AGENDA

PLANNING AND ZONING COMMISSION WORK SESSION MEETING
CITY HALL, 385 SOUTH GOLIAD, ROCKWALL, TEXAS
SEPTEMBER 27, 2022 IN THE CITY COUNCIL CHAMBERS AT 6:00 PM

PLANNING AND ZONING COMMISSION CASE MEMO

TO: Planning and Zoning Commission
DATE: September 27, 2022
APPLICANT: Ryan Miller; *City of Rockwall*
CASE NUMBER: P2022-050; *Final Plat for Lots 1 & 2, Block A, Boys and Girls Club of Rockwall Addition*

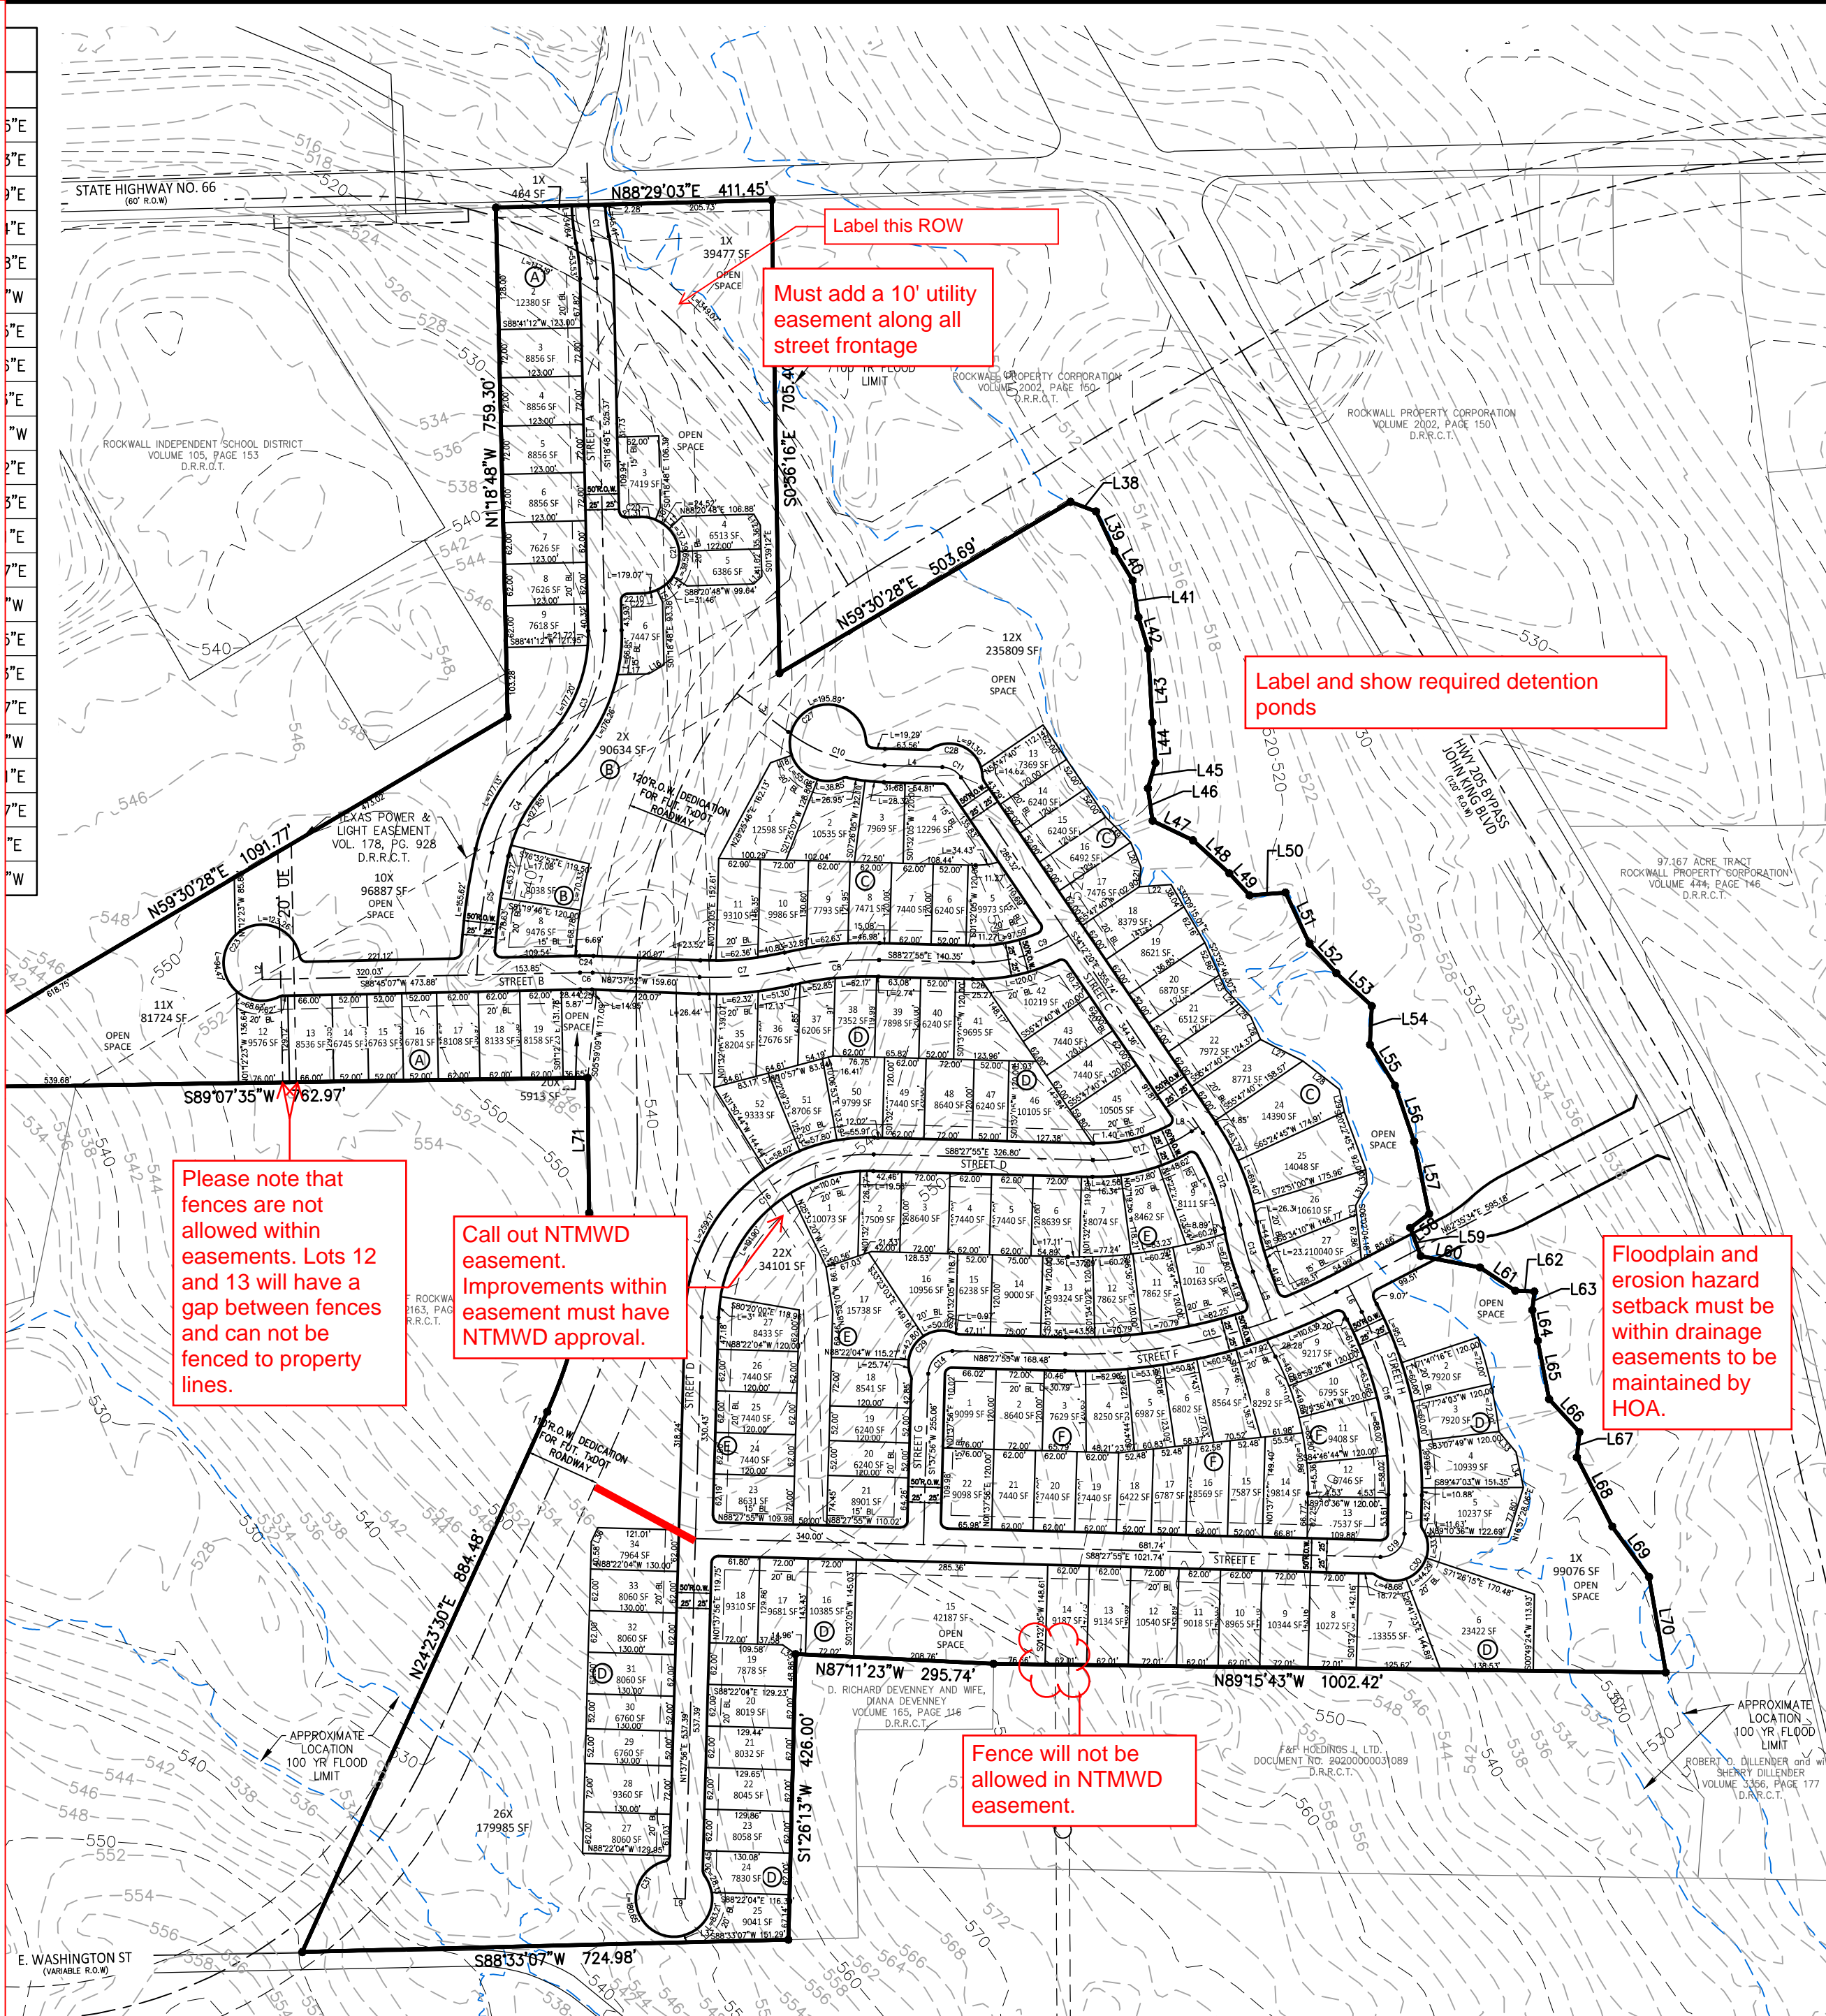
- All frontages must have a 10' utility easement.
- See all master line sizes required. Must tie the water line from John King to the western boundary.
- Must install 12" in future SH 66 from eastern property line to tie into ex. 12" in Washington St. May need to install said 12" to John King and install 16" in John King north to SH 66 then install 12" west. -Will need to do an infrastructure study with fees.
- Need to install 10" sewer along flood plain per Master Sewer Plan or through site with stub outs for eastern property.
- Must loop 8" water line on site.
- Only one "use" off a dead-end line (domestic, irrigation, fire sprinkler, fire hydrant, etc.)
- Must have NTMWD and the power company approval for paving and residential lots in their easement.
- May need to relocate 12" water line on the western area of site.

date: 8/19/22 scale: 1" = 30' sheet: C101

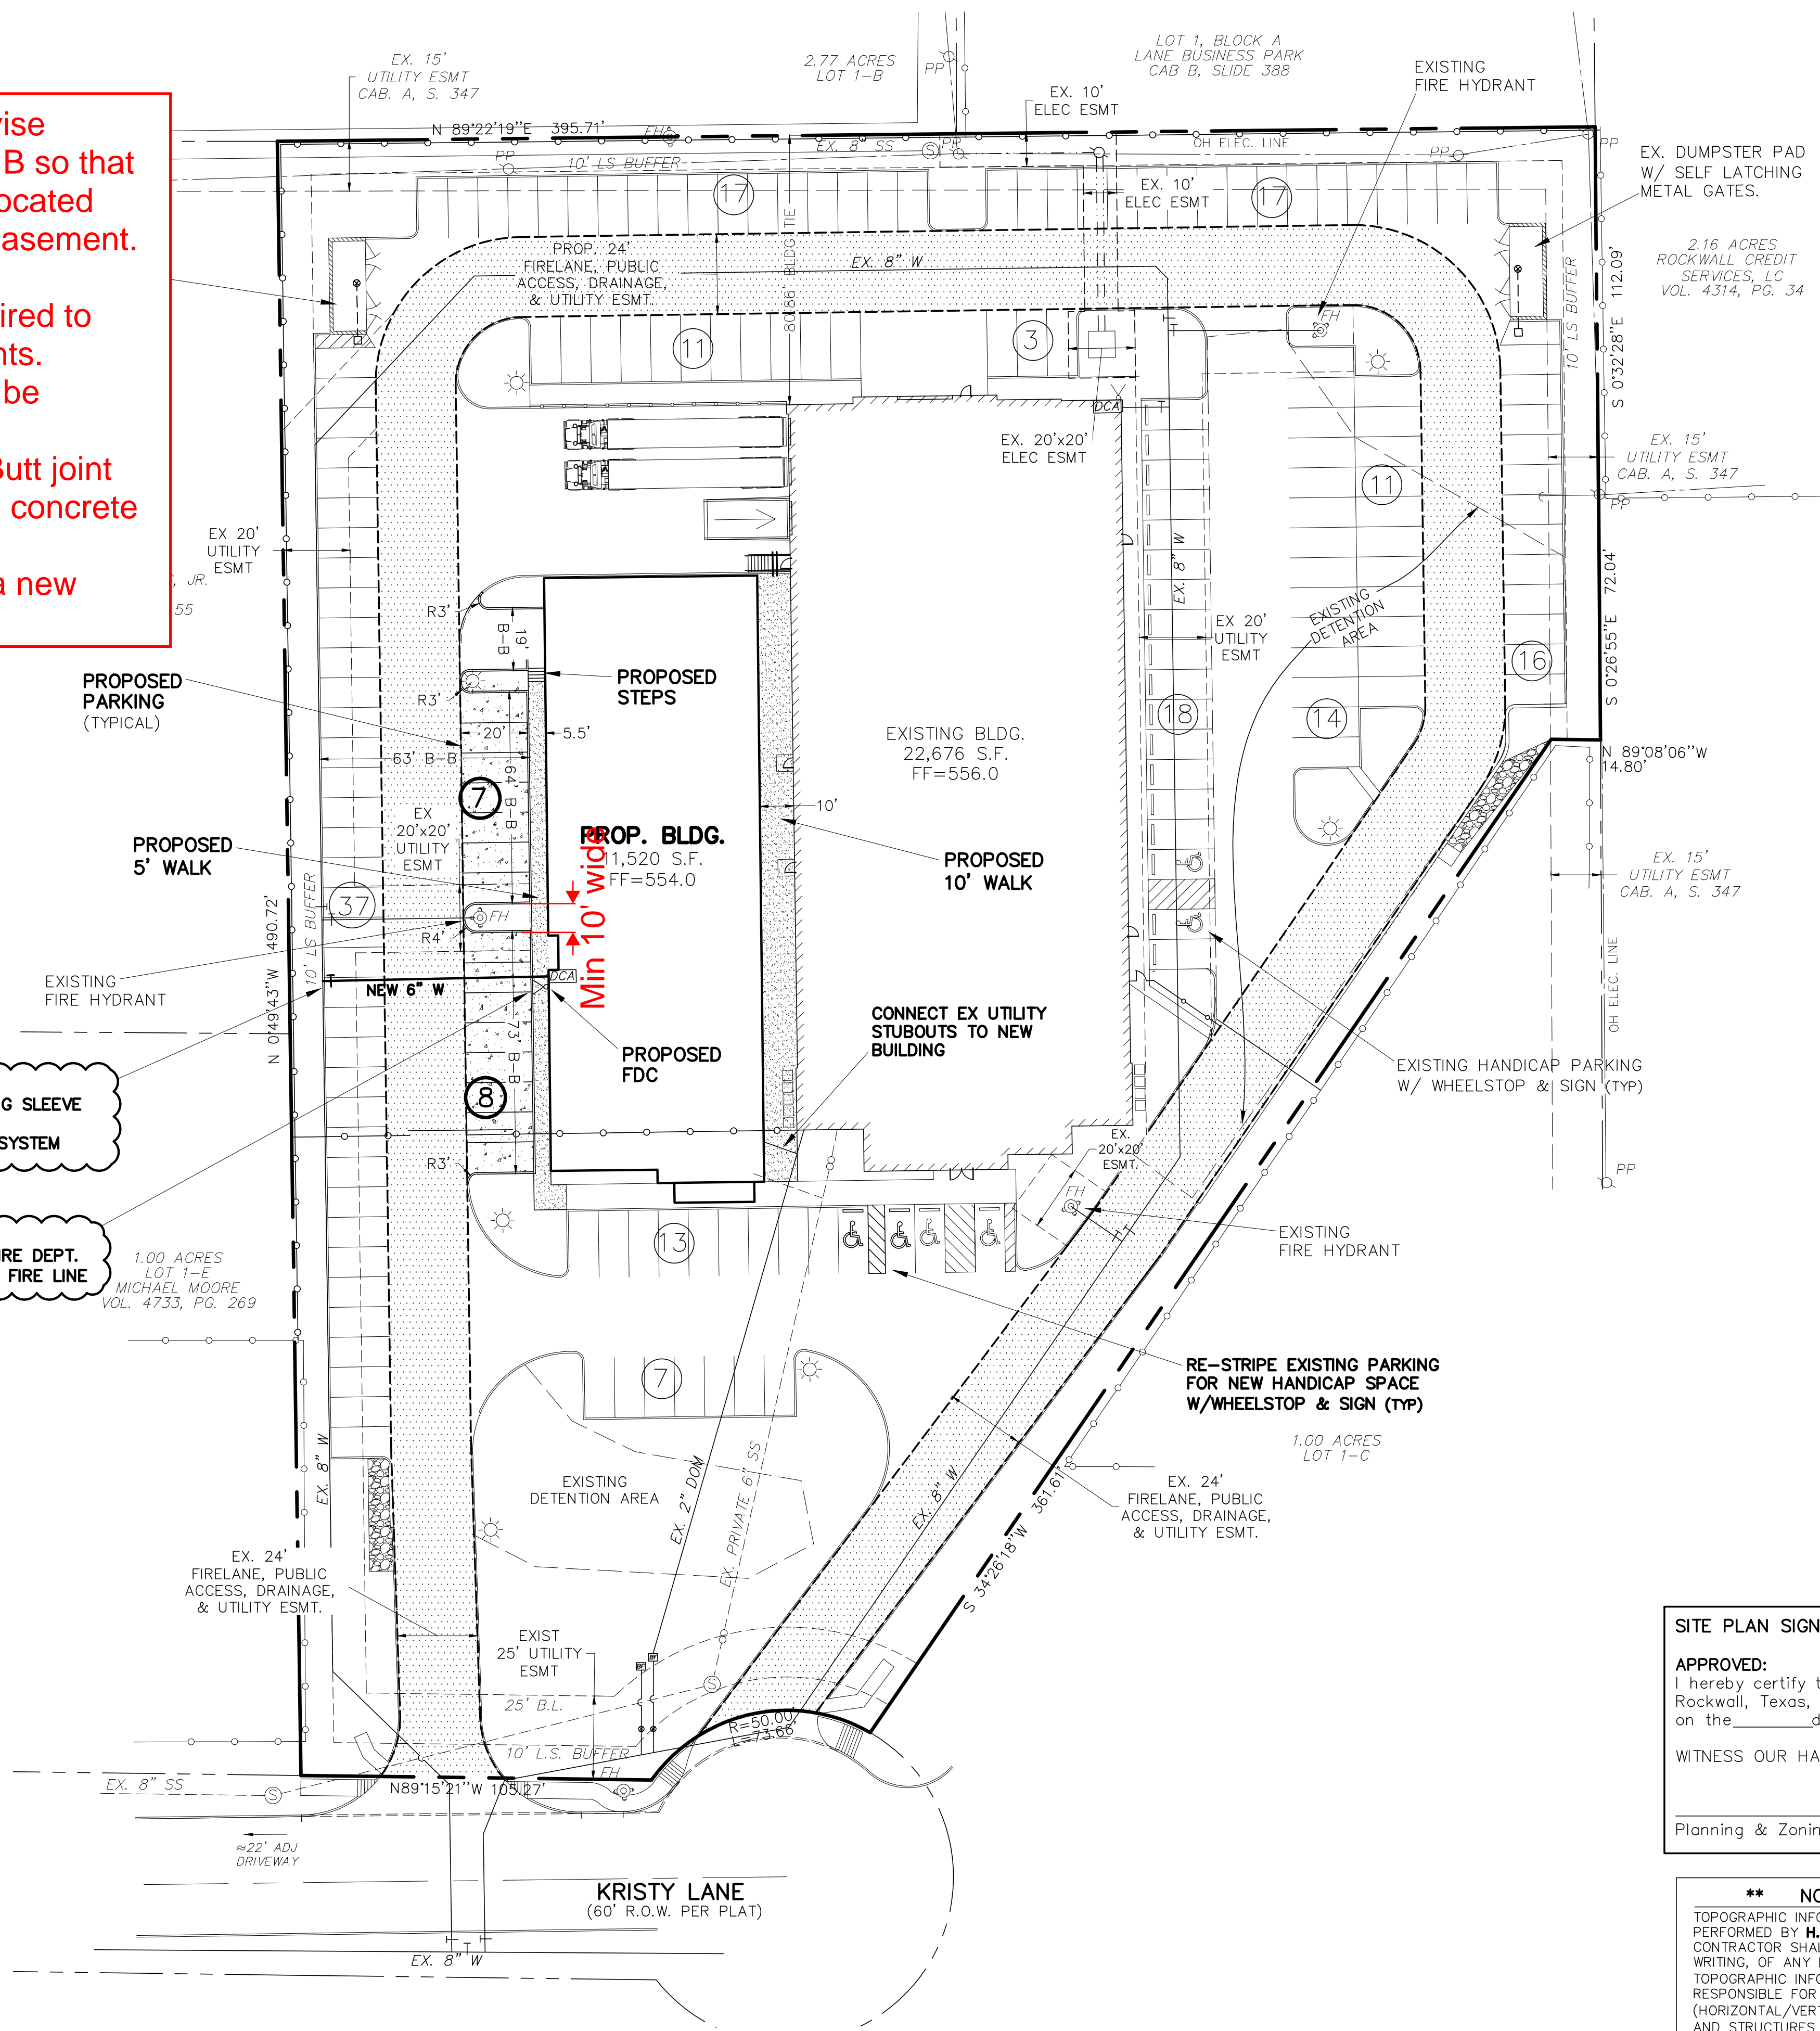
09/19/2022: Please provide a landscape plan for this project

Will need to revise detention pond B so that the building is located outside of the easement. (see last page)
 - Replat is required to revise easements.
 - All paving will be concrete.
 - Longitudinal Butt joint needed to tie in concrete to existing.
 - Will there be a new water meter?
